3		
2	City Review - R.O.W	
1	City Review - Rd & Drain	21 JAN 04

HAMPSHIRE STREET RECONSTRUCTION
AUBURN, MAINE

PLAN / PROFILE STA. 1+00 to STA. 8+50

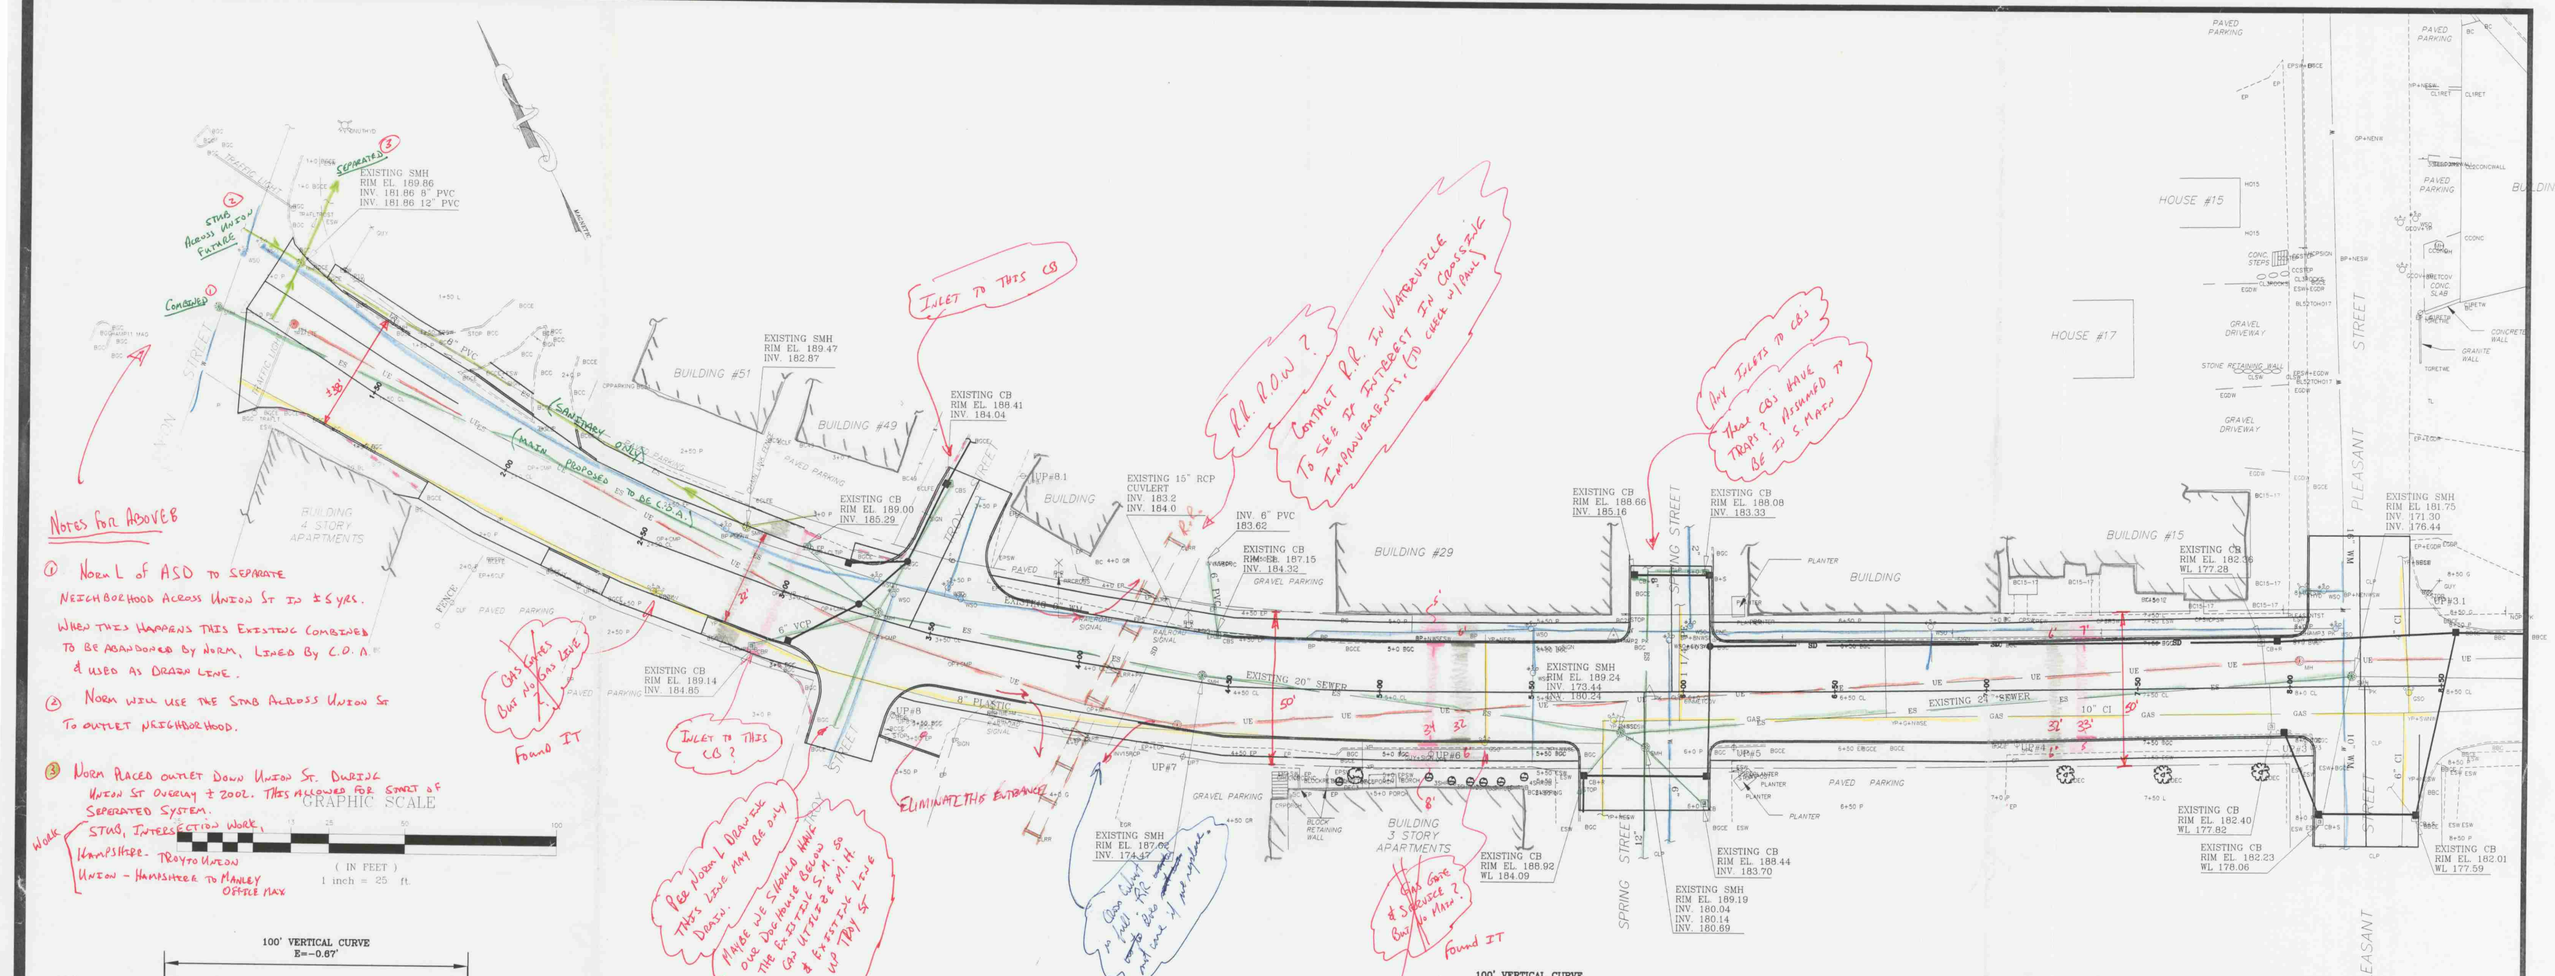
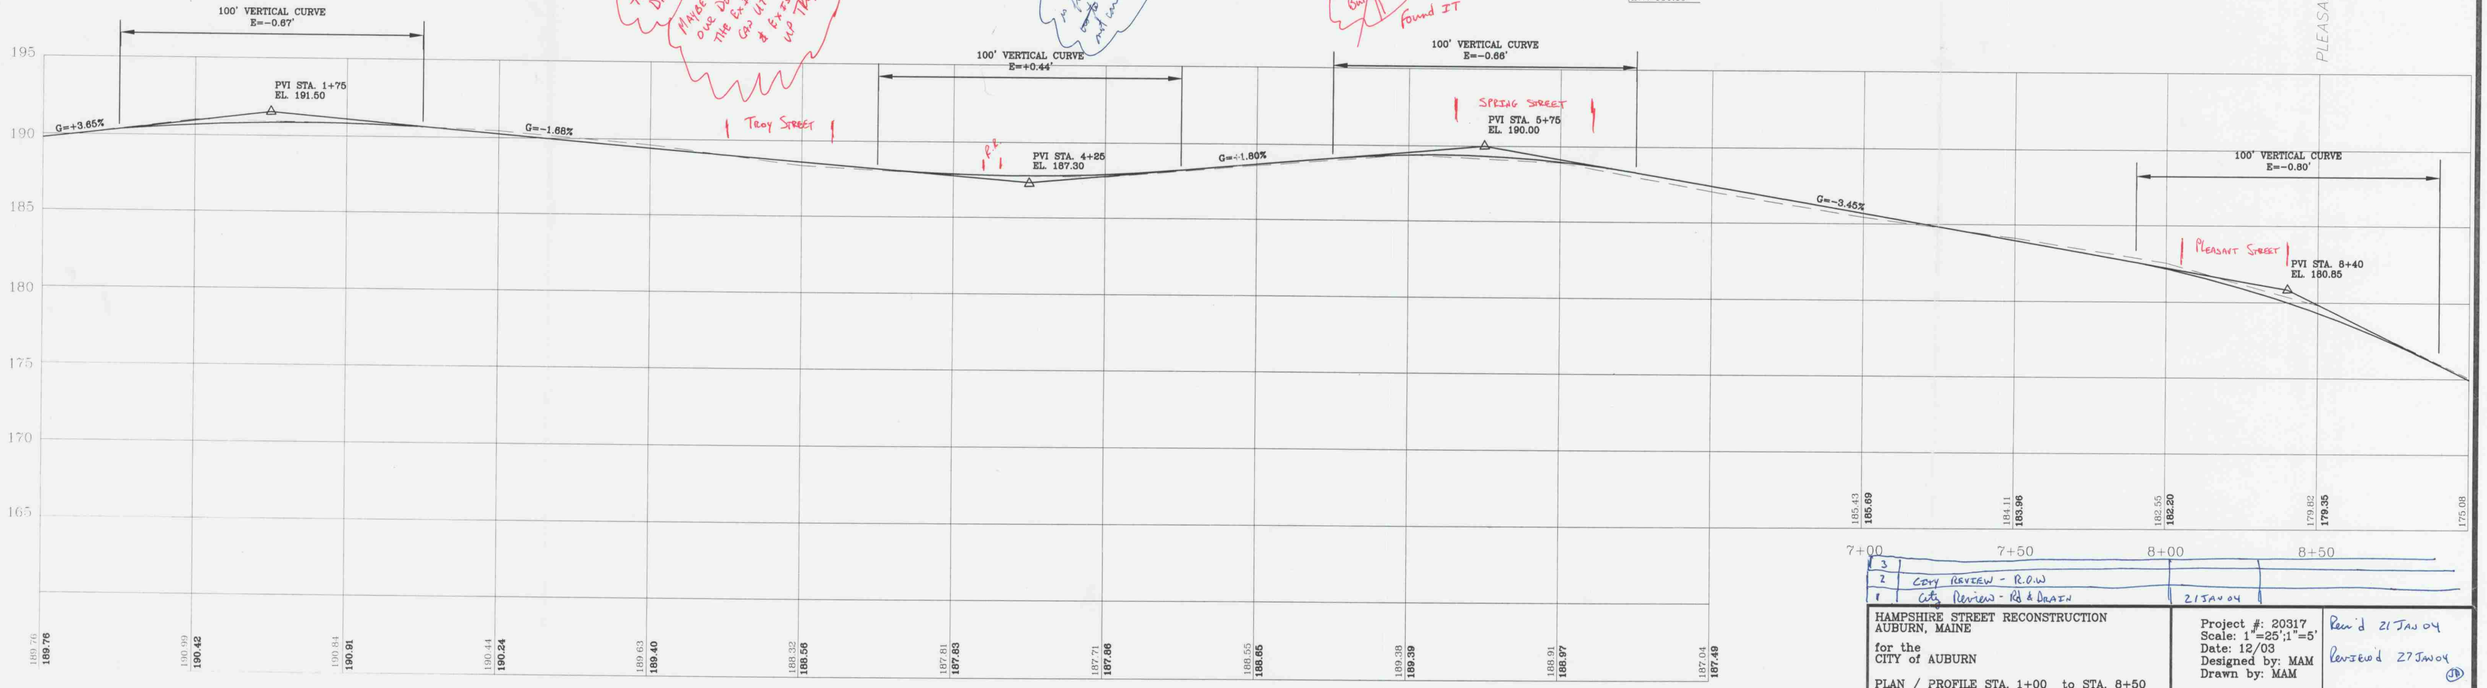
① Norm L of ASD to separate neighborhood across Union St in ±5 yrs. When this happens this existing combined to be abandoned by Norm, lined by C.O.A. & used as drain line.

② Norm will use the stub across Union St to outlet neighborhood.

③ Norm placed outlet down Union St. during Union St overlay ± 2002. This allowed for start of separated system.

Inlet to this CB

R.R. R.O.W.? Contact R.R. in Waterville to see if interest in crossing improvements. (To check w/Paul)

Any inlets to CBs. Have CBs have traps? Assumed to be is S. Main.

Gas lines out no gas line. Found it

Inlet to this CB?

Eliminate this entrance

Per Norm L Drawing this line may be only drain.

Make we should have house below the existing S.M.H. Gas utility be M.H. & existing line up to Spring St

Gas line in field. Not to be used. Not shown on drawing

Gas line to house? Not shown. Found it
